Company	Trenz Electronic GmbH
PCN Number	PCN-20190311
Title	TE0725LP-01 SPI Flash Change
Subject	BOM change
Issue Date	20190311

This change affects all TE0725LP modules of revision 01 : TE0725LP-01

Locate Flash (U7) on backside of PCB:

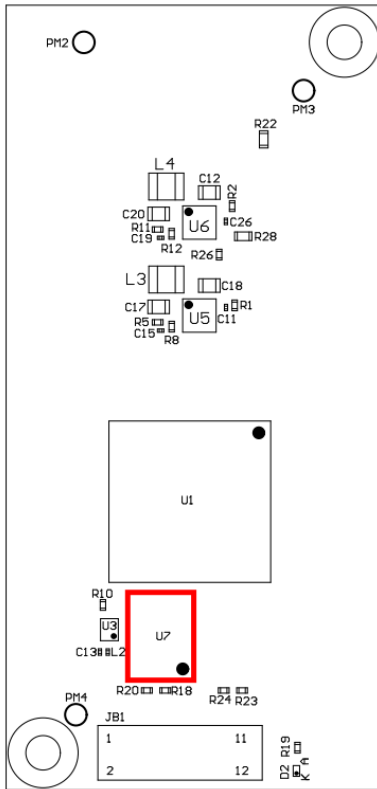
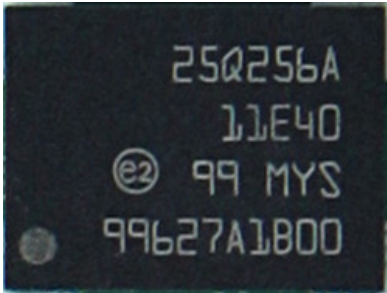
#1 Change SPI Flash from N25Q256A11E1240E to MT25QU512ABB8E12-0SIT

Reason: N25Q256A11E1240E became obsolete.

Impact: Size changed from 256 MBit to 512 MBit. JEDEC ID changed from BB19h to BB20h both with manufacturer ID: 20h.

old	new
N25Q256A11E1240E	**MT25QU512ABB8E12-0SIT**
